VALUE ENGINEERING STUDY REPORT

Operations Buildings Poplar Island

Baltimore District US Army Corps of Engineers

17 March 03

A - 05

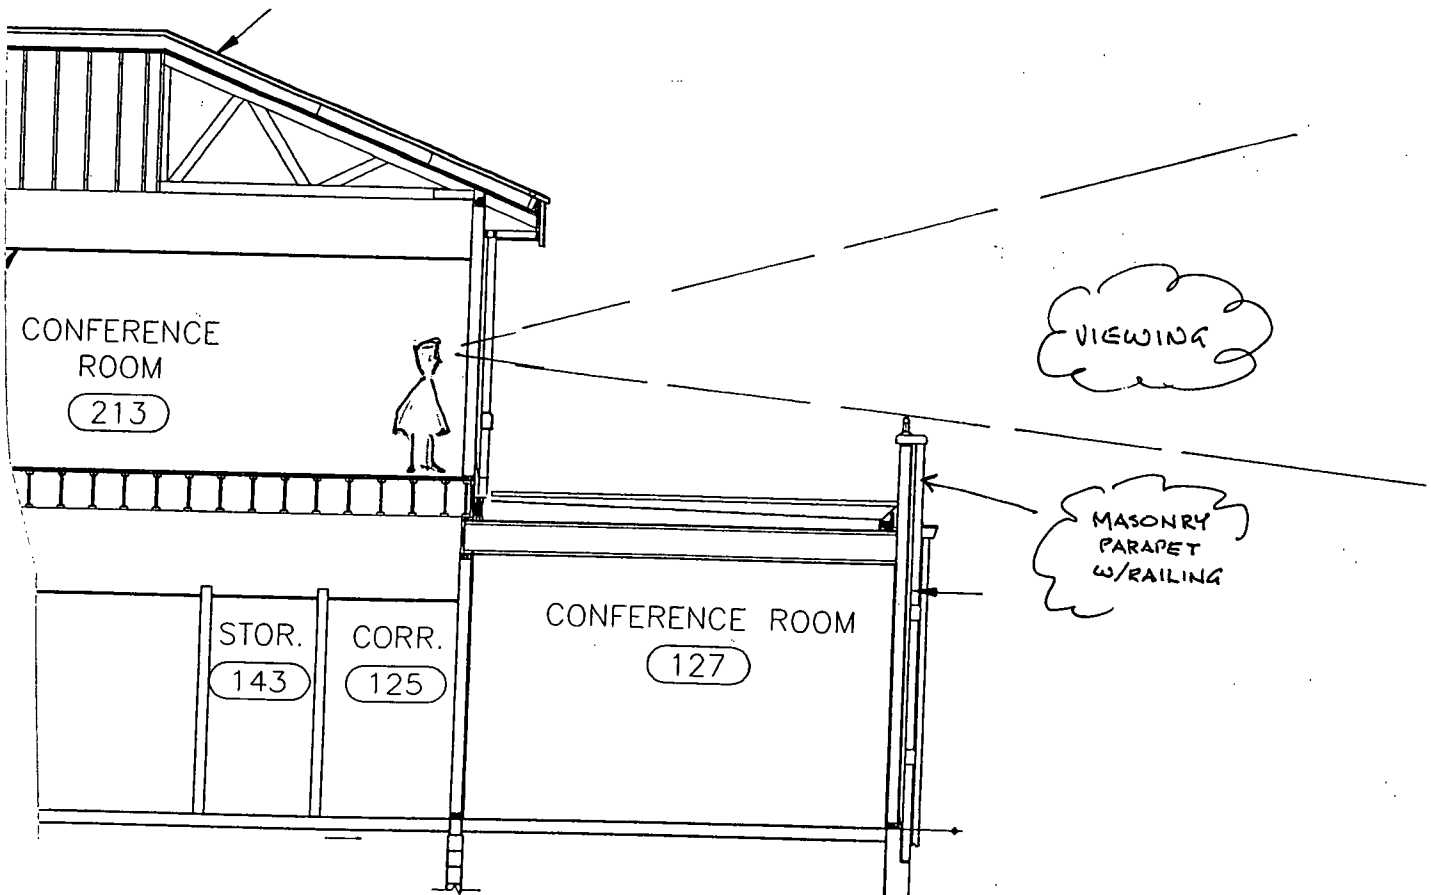
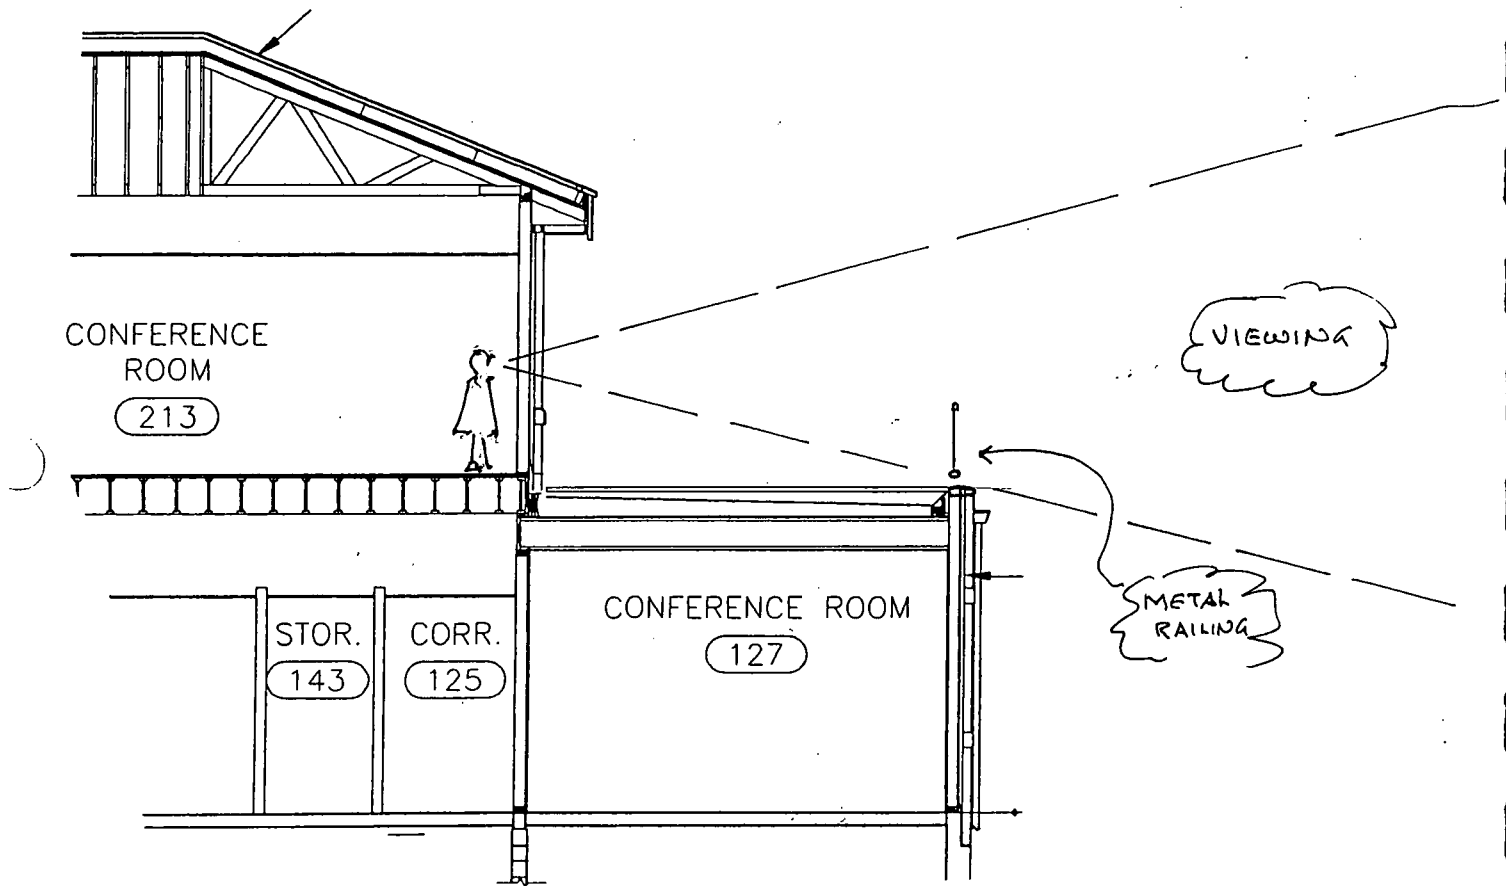
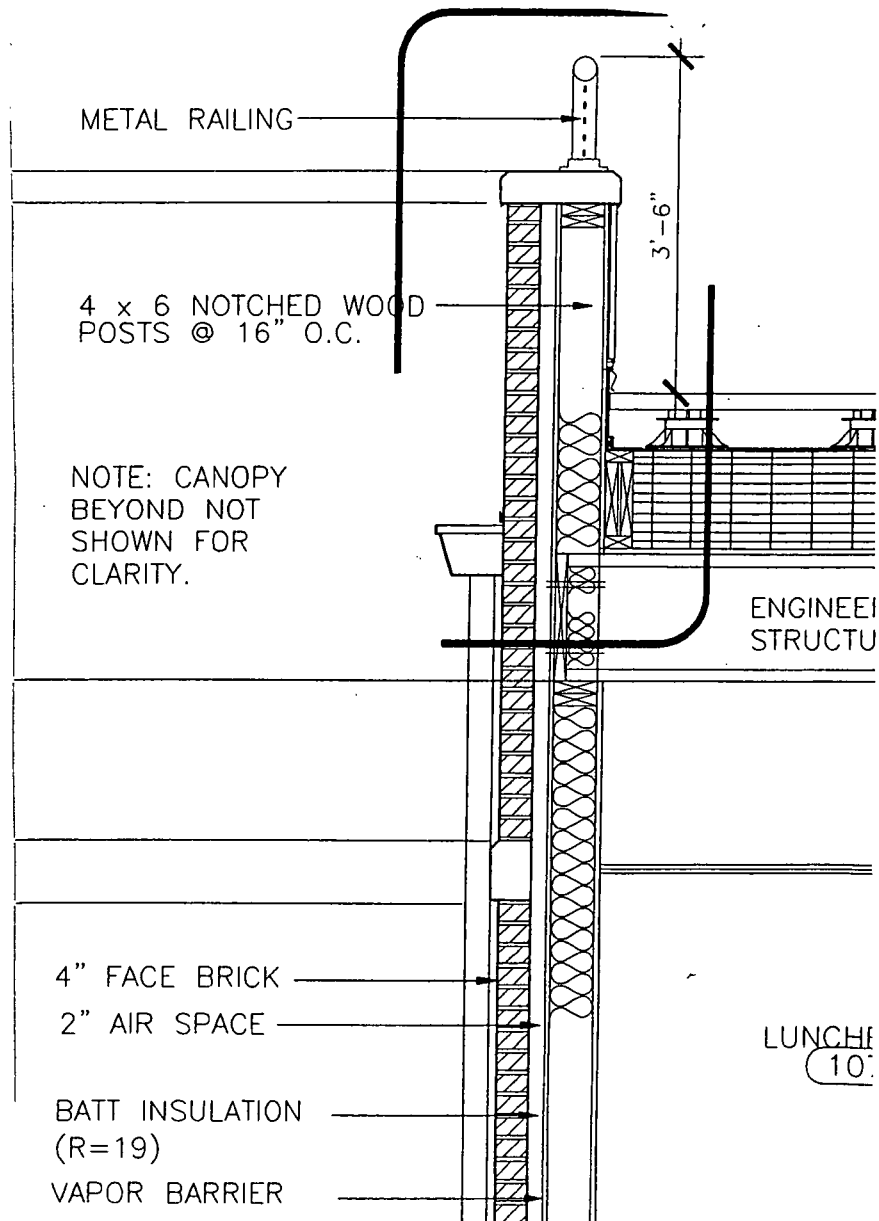
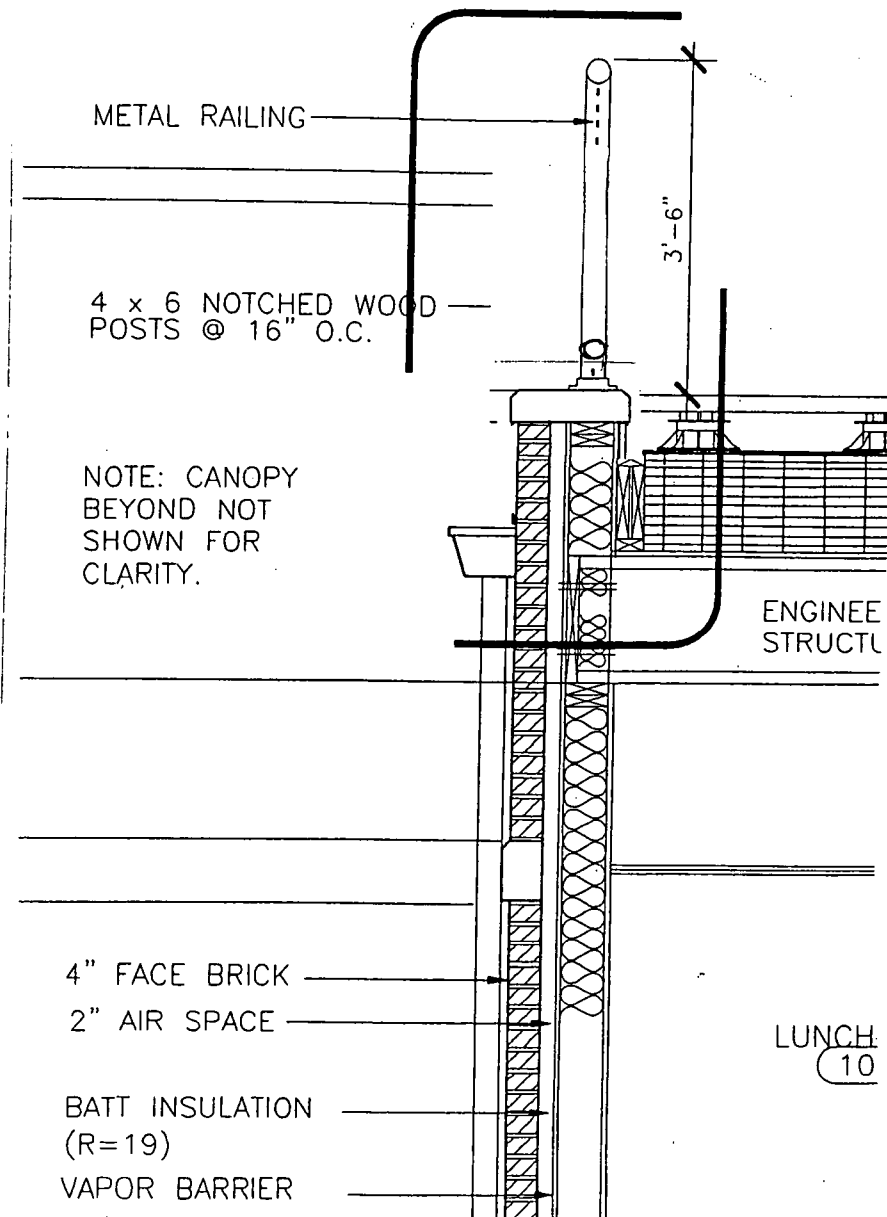
DESCRIPTION: Provide non-obscuring metal railing in lieu of masonry parapet at the Operations Building.

PROPOSED DESIGN: Provide a metal railing, designed for minimal visual obstruction at full perimeter of lower level roof, in lieu of the masonry parapet.

JUSTIFICATION: Per the design briefing, the primary purpose of locating the large conference room at the second floor level is to provide visitors with views of the island restoration project. Since visitors will have access to the observation deck, a perimeter railing is essential. Providing a "transparent" railing rather than opaque (masonry) parapet will significantly expand the viewing area from windows of the conference room. There will also be some cost reduction.

A - 07

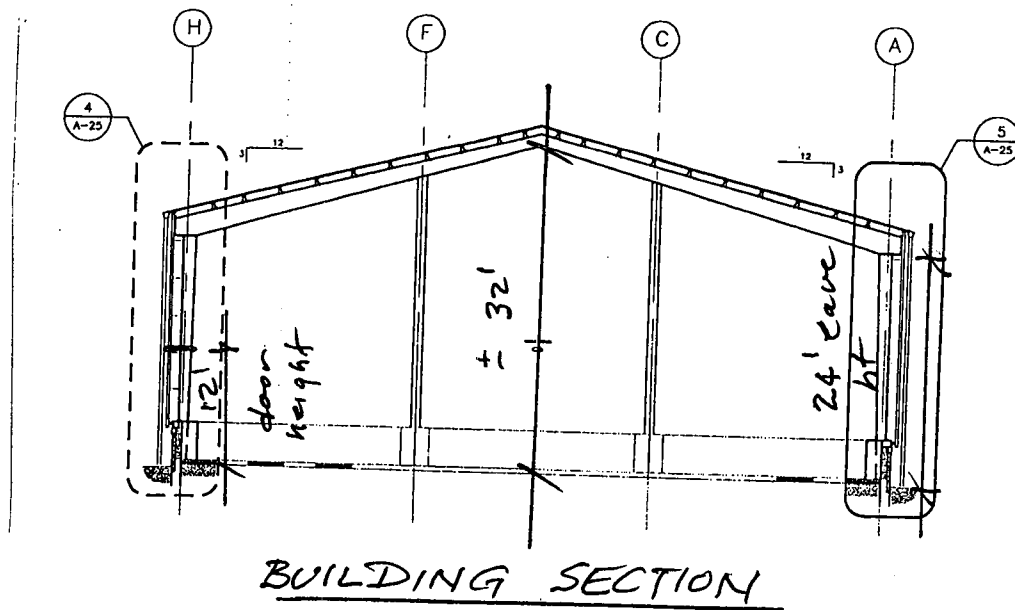
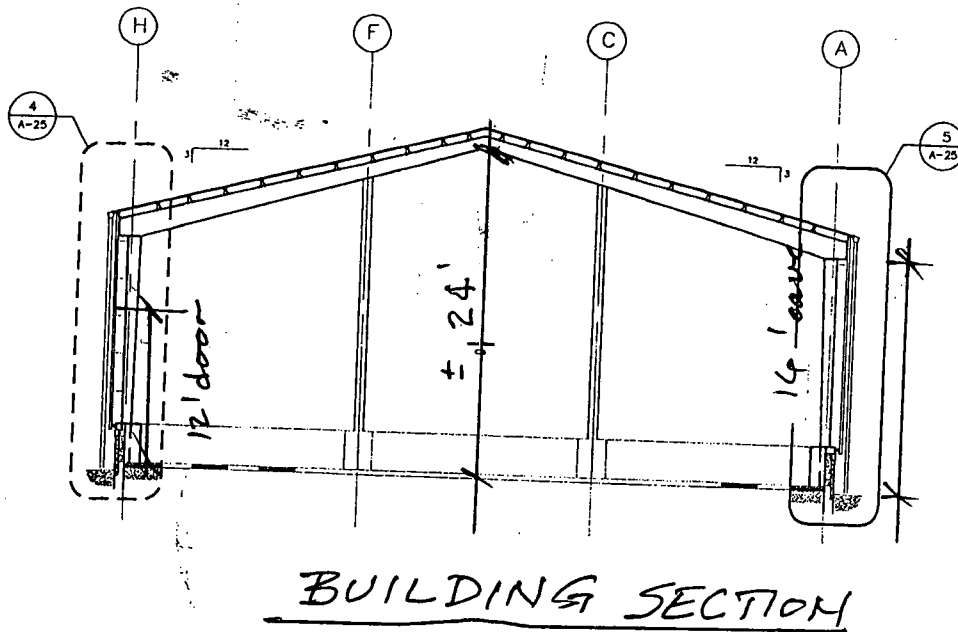
JUSTIFICATION: This structure is to be used for storage of small boats, hovercraft, equipment and palletized materials. It is anticipated that a fork lift type vehicle would be utilized for stacking the pallets. It would appear that the upper volume of a higher structure would be little used or not at all.
